Planning Commission Staff Report

File # 3S25 – SUB-000519-2025

Public Hearing and Consideration of Approval for Preliminary Subdivision Amendment to Create 4 Residential Lots and a Private Lane Exemption Request on 1.42 Acres of Property at 1280 W. Marinwood Ave. in Taylorsville, Utah.

Exhibit F HALLIDAY ESTATES SUBDIVISION AMENDED & EXTENDED

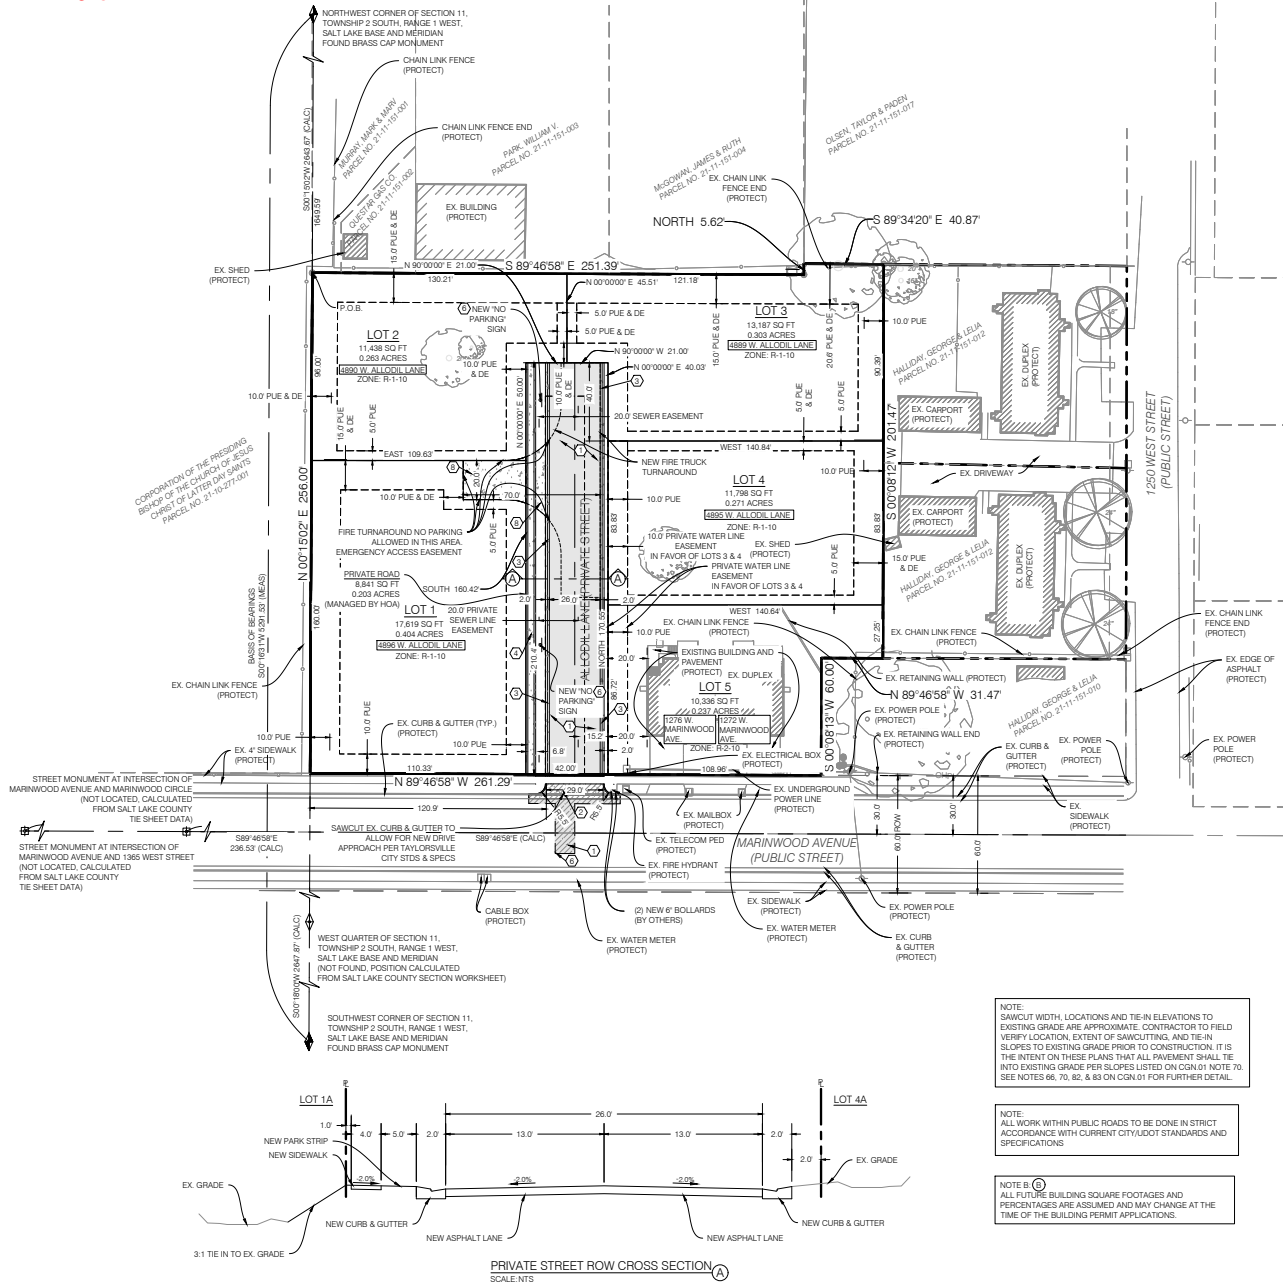
14. Show setbacks for all sides of duplex from new property lines.
15. Adjust the "Area Tables" calculations to reflect correct lot sizes.

UTILITY PLAN
CUP.01
6 OF 12

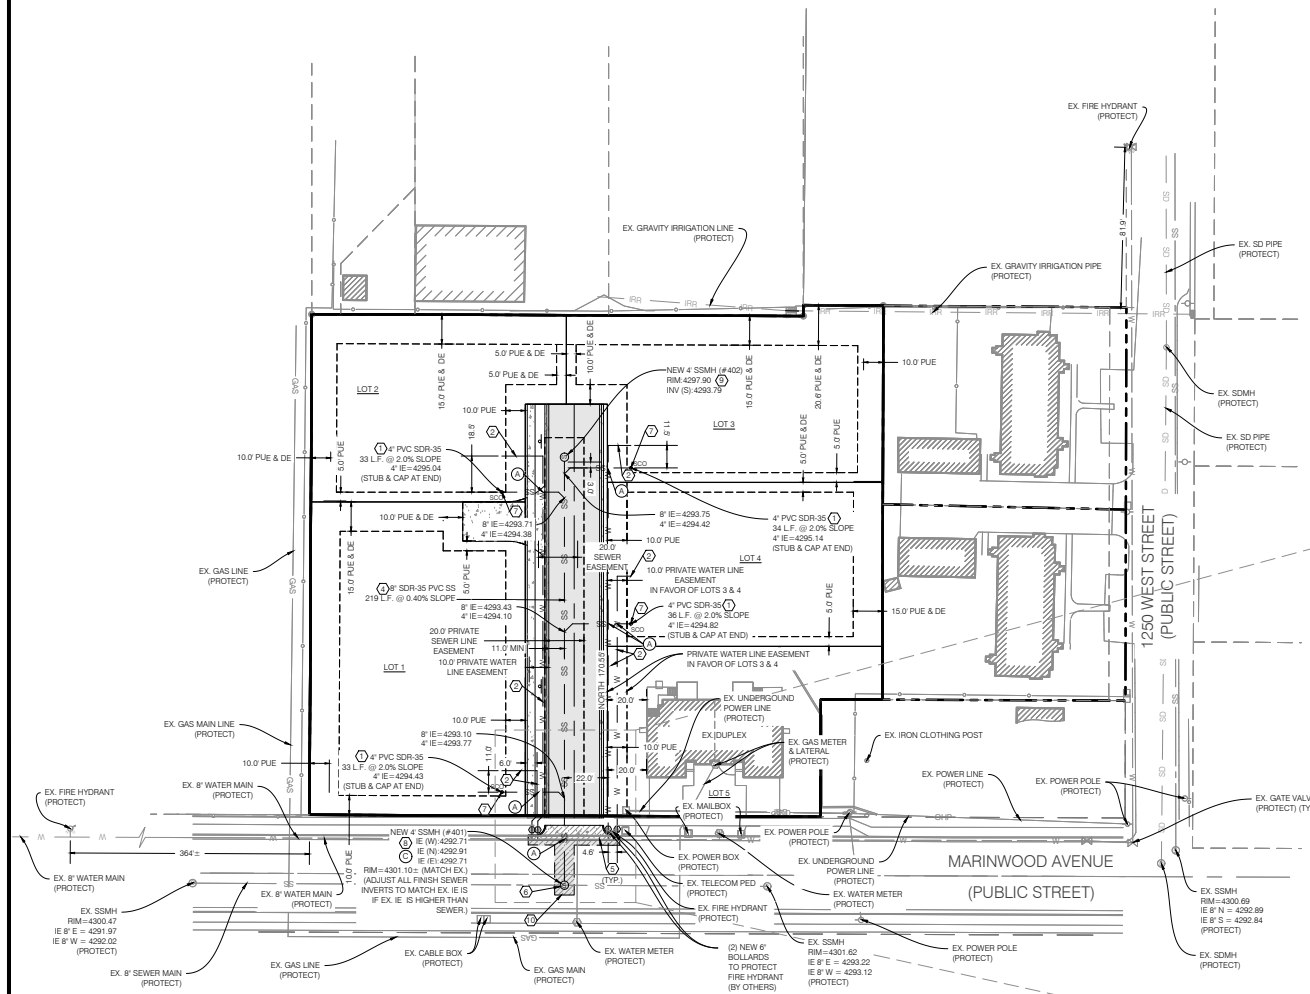
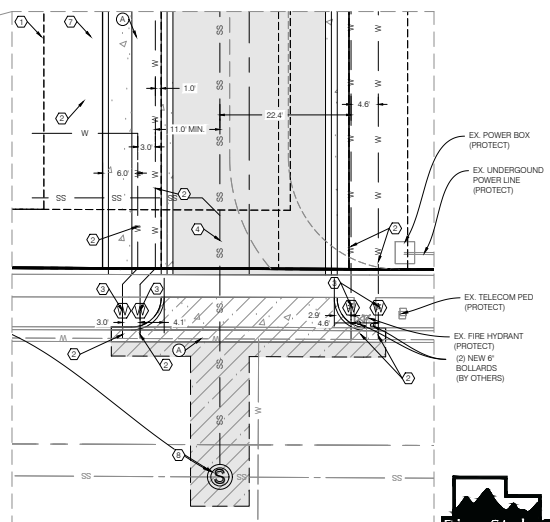
3. General notes need to be updated for this project. Sewer and Water is to be installed to TBID standards including the tapping and installation of water services.
4. If the road is not a public road, 20' easements in favor of TBID for the sewer will need to be granted. Reciprocal easements are needed for the water service lines if the road is not public.
5. Plans call for 1" water service lines. The standard size for residential homes is ¾". There is a significant difference in impact fee costs between the two sizes. You might want to consider resizing of the service.
6. Keyed notes 10 and 13 reference copper service lines- TBID standard is for poly services.
